Rampion 2 Wind Farm

Applicant's Responses to Examining Authority's Second Written Questions (ExQ2)

Application Reference: 8.81

<p>Screenshot from Inset 45 of the updated Arboricultural Impact Assessment submitted at Deadline 4 [REP4-037] indicating a section of W67 (trees not surveyed in detail) indicated in the key as ‘trees to be removed’ (indicated in red)</p>

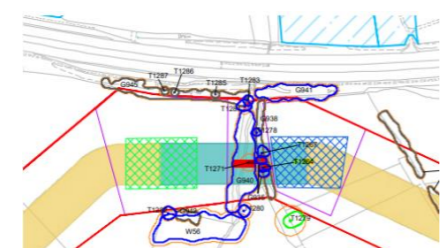
Ref	Question To:	Question	Applicant's response
TE 2.3	<p>Priority Habitats - Potential Loss of Deciduous Woodland</p> <p>The Applicant</p> <p>West Sussex CC</p> <p>The Forestry Commission</p>	<p>The Applicant</p> <p>Comment on the West Sussex CC response [REP4-086] at Deadline 4 to TE1.6 which states:</p> <p><i>“The Woodland Retention Plan, Figure 7.2.2h (B) of the OCoCP [REP4-043], identifies the area of deciduous woodland status within the National Grid Bolney substation as being retained (ref. W3713). This finding is contrary to that stated within the Applicant’s response, as well as plans shown within inset 45 of the Arboricultural Impacts Plan found within the Arboricultural Impact Assessment [APP-194], as well as what can be achieved within the indicative plan for the AIS extension option without adverse impact (as shown within the Design and Access Statement). [REP3-013]. Therefore West Sussex CC remains unsatisfied that the impact on deciduous woodland, a priority habitat, are at all clear at this location.”</i></p>	<p>Wind Farm project undertook a horizontal directional drill (HDD) under Miller’s Wood, near Ipswich, an area of semi-natural ancient woodland. The Code of Construction Practice (EA1 Code of Construction Practice Final (yudu.com)) for the construction phase of this project simply states a ‘sufficient depth’ will be maintained under constraints of all proposed trenchless crossings. In a meeting with Natural England on 28 June 2024, it was confirmed by Natural England that the justification provided was reasonable basis for the specification of a minimum drill depth of 6m. The Applicant has confirmed during the course of the Examination that consultation with the Forestry Commission was conducted during the design evolution of the Proposed Development during the pre-application stage. The mitigation was discussed with and deemed appropriate by the Forestry Commission in a meeting on 29 April 2022 (see paragraph 22.3.19 of Chapter 22: Terrestrial ecology and nature conservation, Volume 2 of the Environmental Statement [REP4-022]).</p> <p>a) Survey of these trees was not undertaken due to the Applicant not being able to obtain land access. The Applicant has noted on the revised plan that survey must be completed in this area to inform detailed design and the stage specific arboricultural method statement and tree protection plans, which are to be provided for the approval of the relevant planning authority as per Requirement 22 of the Draft Development Consent Order [REP4-004]. This would confirm the details of any individual specimens outside the woodland block and how they are affected by the works for which the Appendix 22.16: Arboricultural Impact Assessment, Volume 4 of the Environmental Statement (ES) [REP4-037] has been updated to assume 4 based on aerial imagery.</p> <p>b) Appendix 22.16: Arboricultural Impact Assessment, Volume 4 of the ES [REP4-037] has been updated at Deadline 5 to reflect the Outline Vegetation Retention and Removal Plan (Document Reference: 8.87) in this area leaving the woodland block retained. This is the correction of an error in the Appendix 22.16: Arboricultural Impact Assessment, Volume 4 of the ES [REP4-037]. The Applicant has undertaken a comprehensive review of Appendix 22.16: Arboricultural Impact Assessment, Volume 4 of the ES [REP4-037] and Outline Vegetation Retention and Removal Plan (Document Reference: 8.87), in line with the West Sussex County Council response [REP4-086] to address any inconsistencies.</p>

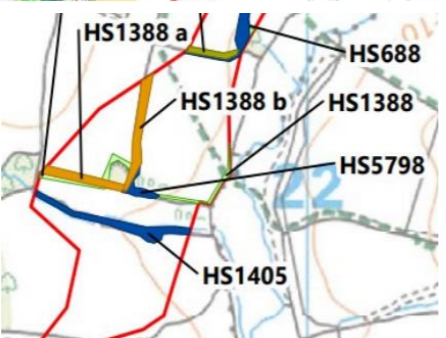
Ref	Question To:	Question	Applicant's response
	<p>T611, T613 & T617 - Pedunculate Oaks of Middle / Mature Age above a Trenchless Crossing</p>	<p><i>“An updated version of Appendix 22.16: Arboricultural Impact Assessment, Volume 4 of the Environmental Statement (ES) [APP-194] will be submitted at Deadline 4 to show these trees as retained. These trees were originally shown as lost on a precautionary basis as the limit of deviation for the trenchless crossing compound TC22a which overlapped with the root protection areas. However, the Applicant can now confirm that these trees (T609, T611, T613 & T617) would be retained as part of the Proposed Development”.</i></p>	<p>The Applicant can confirm Trees T609, T611, T613 and T617 are to be retained.</p>
	<p>The Applicant</p>	<p>However, the updated Arboricultural Impact Assessment submitted by the Applicant at Deadline 4 [REP4-037] lists trees T609 and T611 (Pedunculate oak of middle age) and T613 and T617 (Pedunculate oak of mature age), in Table 7-8 Possible tree removal due to alternative HDD crossings and Limits of Deviation, which is inconsistent with the response the Applicant gave to the Examining Authority's question TE 1.9 and also inconsistent with the screenshot of Inset 34 of Annex 2 of the Arboricultural Impact Plan [REP4-037], shown below, which indicated the trees would be retained.</p>

<p>Explain this apparent inconsistency and confirm how these trees would be treated, ensuring if necessary, that the Arboricultural Impact Assessment Table 7-8 is updated and resubmitted accurately at Deadline 5.</p>	
<p>TE 2.5</p>	<p><i>Potential loss of Category A Trees</i></p> <p>The Applicant</p>	<p>Comment on the West Sussex CC response [REP4-086] at Deadline 4 to TE1.7 which states:</p> <p><i>“Whilst welcomed to hear that the Applicant carried out a tree survey prior to determining the substation location and that veteran trees and priority habitats were considered, the Applicant’s response lacks confidence that assigned tree values in accordance with BS5837:2012 were a consideration for selection of any substation location. The location has a proposed loss of 11 of the 14 ‘A category’ trees identified across the entire DCO Limits”.</i></p>	<p>The onshore substation footprint has been designed to represent a realistic worst-case scenario and allows enough space to account for the greatest power output possible from the wind farm and accommodate four transmission cables. The footprint was optimised (with extent minimised) based on the Oakendene site shape, with effort made to avoid loss of trees within G194. Changing the design (for example to be narrower on an east west axis, but longer on a north south axis would have seen the loss of additional trees that are to be retained further north within the site. Also, it was necessary to consider optimal placement with regards landscape and visual effects, the setting of Oakendene Manor and areas of flood risk.</p>

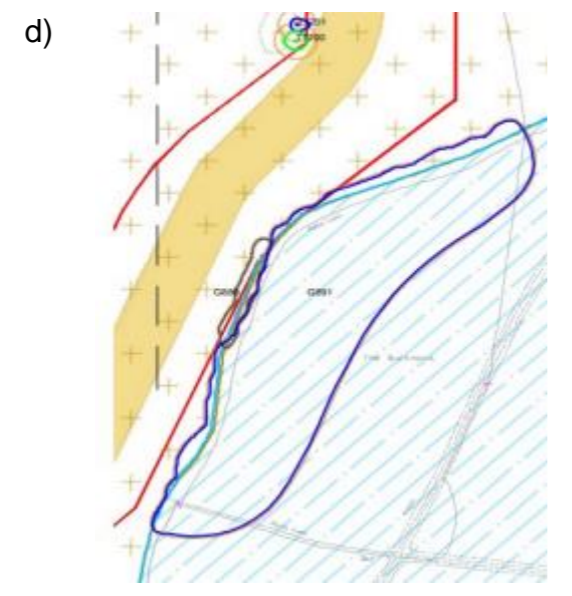
In the vicinity of Bolney substation. If the intention is to carry out a form of activity within 25m of ancient woodland here, explain in detail what that activity could be. If no activity would occur, justify the reason for the land being within the DCO redline boundary. Screen shot taken from Inset 45 of Annex 2 Arboricultural Impact Plan of the Arboricultural Impact Assessment Revision B [REP4-037]. Ancient woodland indicated by light blue shaded area.
